H12167

DESCRIPTIVE REPORT

General Locality Kuskokwim River

Sublocality 10 NM NNE of Helmick Point

Figure 8 – Example of shoreline discrepancy on chart 16304. Multibeam coverage and single beam soundings plotted on top of chart, showing up to 800 meters of discrepancy in the MHW line.

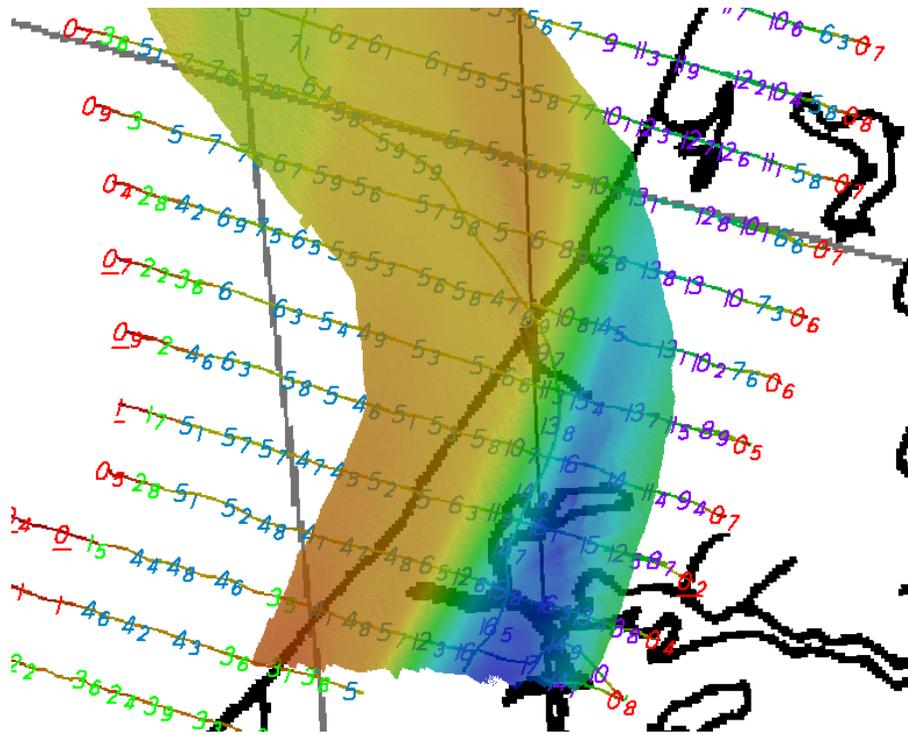
- Survey data shows up to 800 meters of discrepancy with shoreline as portrayed on chart 16304 in the vicinity of 60-21-57 N, 162-20-24 W, due to significant erosion of the river bank. This survey was not tasked with shoreline verification; recommend updating shoreline detail³⁰. See figure below.

³⁰ Concur. Update shoreline with latest GC from RSD.
